# MEMORANDUM

<b>Date:</b> February 22, 2022	
<b>To:</b> Christy Fischer	<b>Organization:</b> Trust for Public Lands
<b>From:</b> Brian Hannegan	<b>Title:</b> Manager of Landscape Architecture
<b>Project Name:</b> Yellow Bank Trailhead	<b>Project Number:</b>
<b>Topic:</b> Concept design of the Yellow Bank Trailhead on Bureau of Land Management Property

Re: Cotoni-Coast Dairies National Monument – Yellow Bank Access Evaluation, Santa Cruz County, California

**Attachment 1**  
**Highway 1 / Yellow Bank Trailhead Entrance**  
**Intersection Channelization**  
**Schematic Plan**

## YELLOW BANK TRAILHEAD

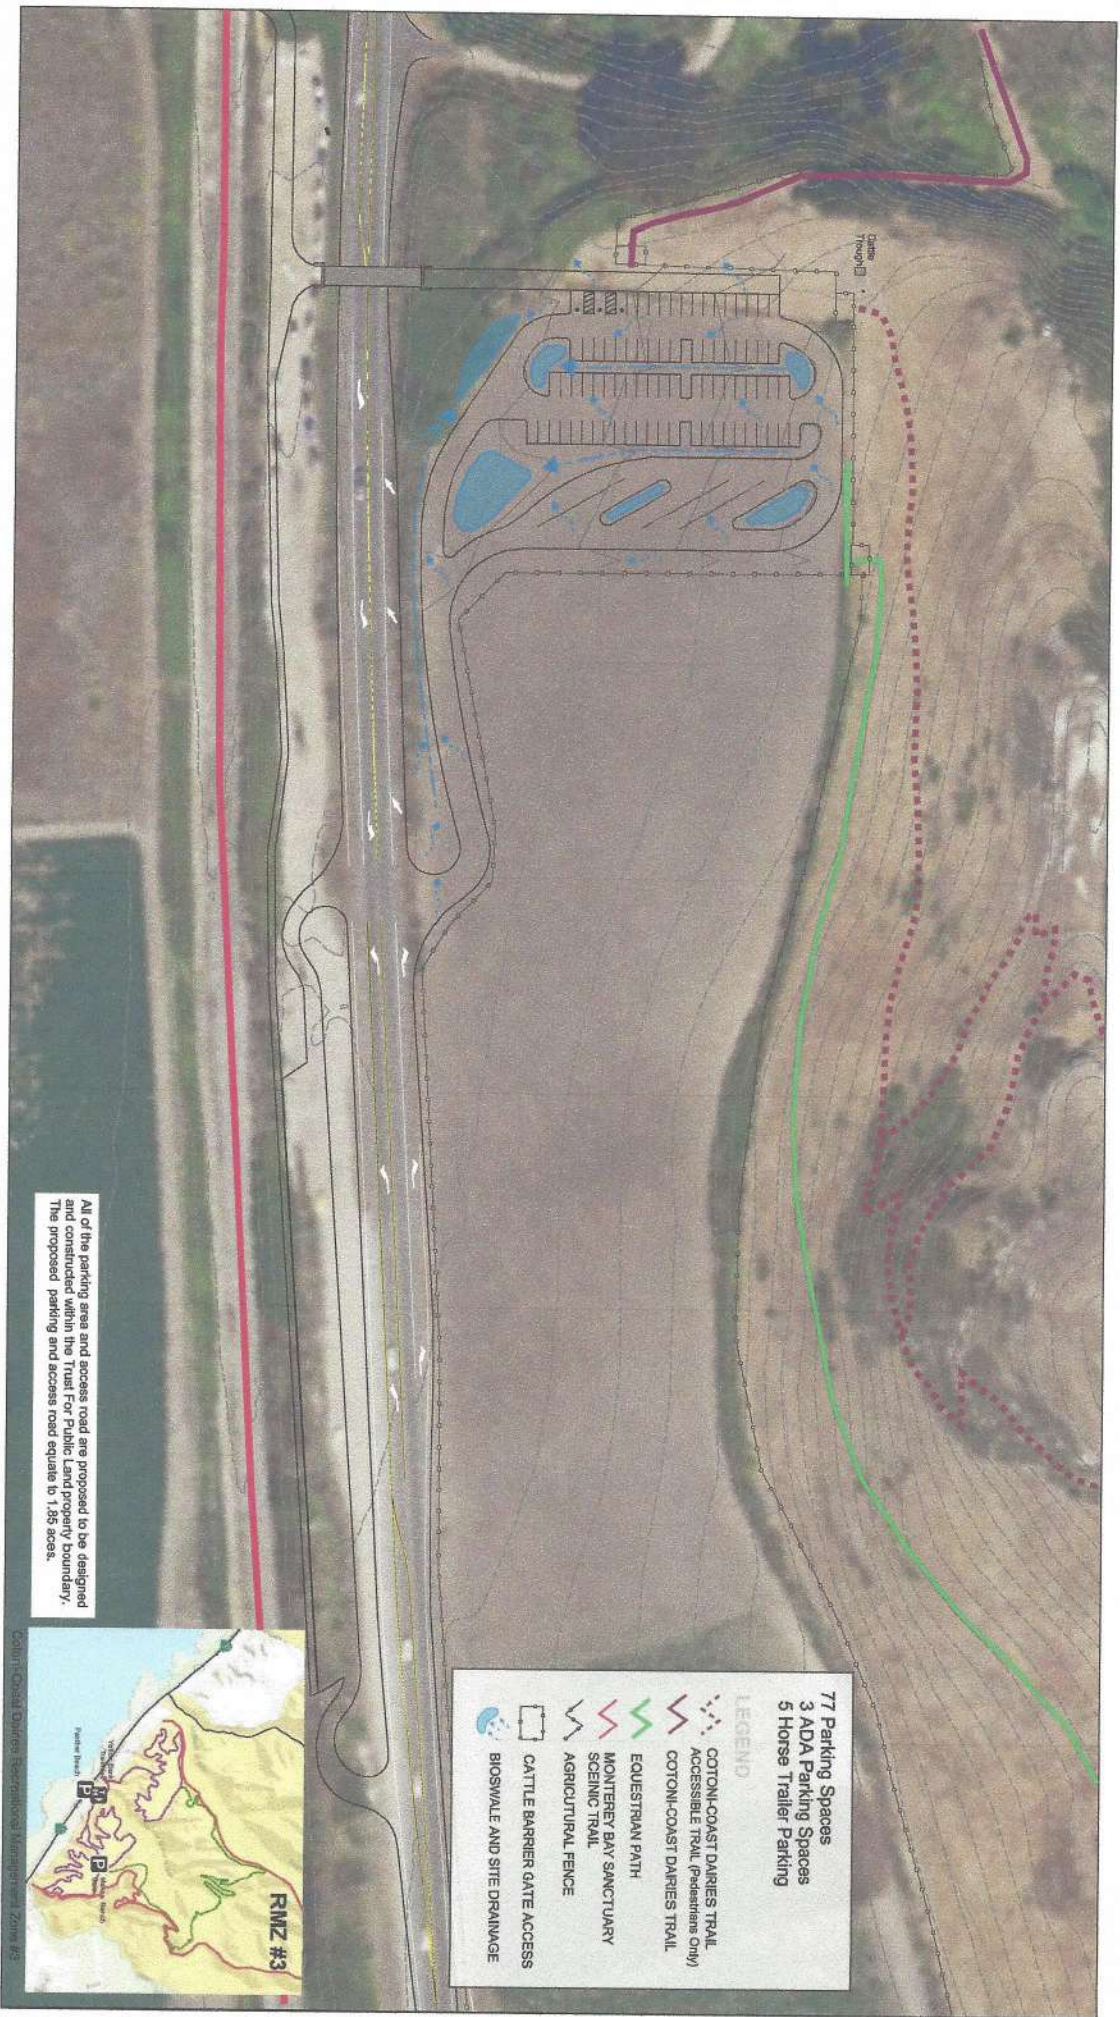
Per your request, this is a preliminary traffic assessment of the schematic plan you prepared dated October 20, 2021, of the proposed Yellow Bank parking lot intersection with Highway 1 (Proposed Driveway Intersection) across from the Santa Cruz Regional Transportation Commission (SCCRTC) Panther Beach parking lot entry intersection with Highway 1. The schematic plan, which does not provide dimensions, is included herein as **Attachment 1**. The Yellow Bank parking lot is being considered by the Bureau of Land Management (BLM) and Trust for Public Land (TPL) as a new option to serve the Cotoni-Coast Dairies National Monument in northern Santa Cruz County, California. It will likely include a pedestrian /bicycle bridge over Highway 1 that will provide pedestrian and bicycle access to Panther Beach and the Monterey Bay Sanctuary Scenic Bike Trail (Scenic Trail).

The proposed Yellow Bank parking lot driveway (Proposed Driveway) is proposed to be directly across Highway 1 from the proposed location of the entrance to the Panther Beach parking lot that will be constructed as a part of the Monterey Bay Sanctuary Scenic Bike Trail. This is also the approximate location of the driveways serving the existing unimproved Panther Beach parking lot. The Proposed Driveway would represent the fourth leg of the proposed intersection. To my knowledge, there is no formal restriction to driveway access at this location. The topography in the vicinity of the Proposed Driveway on the inland side of Highway 1 at this location is hilly but the slopes appear to be gradual enough to accommodate an entrance road to the parking lot such that acceptable horizontal and vertical entrance road alignments can be provided. The proposed driveway location should be acceptable to Caltrans subject to non-traffic considerations such as drainage, storm water quality, habitat conservation and endangered species, etc. The California Coastal Commission may have non-traffic issues as well.

- a. Sight distance looking south: The proposed driveway intersection location is near the north end of a crest vertical curve that limits sight distance to the south (left) for vehicles that would be exiting the proposed driveway location. A site visit was conducted on Sunday, August 28, 2021, to verify sight distance and field conditions in the Proposed Driveway vicinity. A total of 6 time gap readings were taken, with northbound vehicles approaching from the south visible for between 10.1 seconds and 13.1 seconds as they approached the approximate location of the Proposed Driveway. These exceed the requirement of 9.5 seconds per HDM Table 405.1A – “Corner Sight Distance Time Gap (Tg) for Unsignalized Intersections” to accommodate single unit trucks. This is greater than the typical requirement of 7.5 seconds to accommodate passenger cars but is the recommended criteria to provide for trucks with horse trailers, which would utilize this driveway. Adequate sight distance is provided to the south.

- b. Sight distance looking north: The Proposed Driveway is located about one-fourth mile south of Bonny Doon Road. There is a large radius horizontal curve between Bonny Doon Road and Proposed Driveway location. This does not appear to limit sight distance to the north to observe southbound traffic on Highway 1 approaching the Proposed Driveway Intersection. Adequate sight distance is provided to the north.

- c. The sight lines will be measured from a point 15 feet clear of the southbound travel way, which is the shoulder stripe. The embankment along the east side of Highway 1 in the vicinity of the Project Driveway will need to be designed to avoid encroaching into the sight line. This will need to consider future vegetation in the vicinity of the intersection.

- a. Left turn Deceleration Lane - No left turn channelization is currently provided at the existing Panther Beach parking lot driveway. A northbound left turn lane is proposed to be provided at the Panther Beach parking lot as a part of the Scenic Trail. A southbound left turn lane would be required as shown on Attachment 1. This will need to accommodate a minimum of two vehicles of storage, which would include one passenger car and one passenger car/pickup truck with a trailer. It will also need to accommodate deceleration. The posted speed limit is 55 miles per hour which indicates a design speed of about 60 miles per hour. Caltrans may allow 10 to 20 miles per hour of deceleration in the through lane, with about 40 to 50 miles per hour of deceleration in the left turn lane. Transitions from the existing centerline stripe to the left turn lane median width at the design speed of 60 miles per hour needs to be accommodated as well. The basic layout alternatives are indicated in HDM Chapter 400 – Figure 405.2A through C. These result in substantially different improvement lengths with varying construction costs and environmental effects. Some of the design criteria has likely been established during the design of the Panther Beach left turn lane. Caltrans should be consulted prior to proceeding into detailed channelization design. The California Coastal Commission may also have approval authority and is essential to be included early in the design process.

- b. Left Turn Acceleration Lane – A Left turn median acceleration lane (MAL) is apparently not being proposed for the Panther Beach left turn lane improvement. This component of the intersection would be similar to the MAL provided for eastbound left turns exiting the Wilder Ranch driveway. It does not appear that a MAL will be warranted based on level of service, which would be associated with unacceptable delay for left turns exiting the Proposed Driveway. This feature will need to be evaluated in consultation with Caltrans. It would add 12 feet more to the pavement width and much longer approach tapers with the associated impacts on habitat and construction costs.

- c. Right Turn Deceleration Lane – The northbound right turn volumes to enter the Proposed Driveway will be low and probably will not warrant full right turn deceleration lanes. If required, the deceleration lane would have a similar length to the left turn lane, although there would not be a vehicle storage requirement because right turns would be able to enter the Proposed Driveway without yielding to any conflicting traffic movement. At a minimum, a right turn deceleration flare will be required, conforming with HDM Figure 205.1, "Access Openings on Expressways."

- d. Right Turn Acceleration Lane – A right turn lane is unlikely to be required due to the low volume delay anticipated of this movement. However, a right turn acceleration flare will be required conforming with HDM Figure 205.1, "Access Openings on Expressways."

- e. Bike Lane - A bike lane may be required between the right turn lane and northbound travel lane. However, the shoulder width along Highway 1 is as narrow as 3 feet, which is not

adequate to provide a bike lane elsewhere along Highway 1. In addition, the Scenic Trail will provide a facility for bikes that would remove them from the high speed roadway in this area. This element of the design will need to be verified with Caltrans early in the design process.

- f. Entrance Road Alignment – The entrance horizontal alignment will need to accommodate cars and pickup trucks with horse trailers.

Based on the site visit, the entire Proposed Driveway Intersection channelization and sight distance provisions will be able to be physically accommodated at the proposed location. Caltrans will require much more detailed analysis of sight distance, traffic volumes, traffic operations, crash history as well as improvement plans showing horizontal and vertical alignment and supporting environmental, geotechnical, hydrology and other documents.
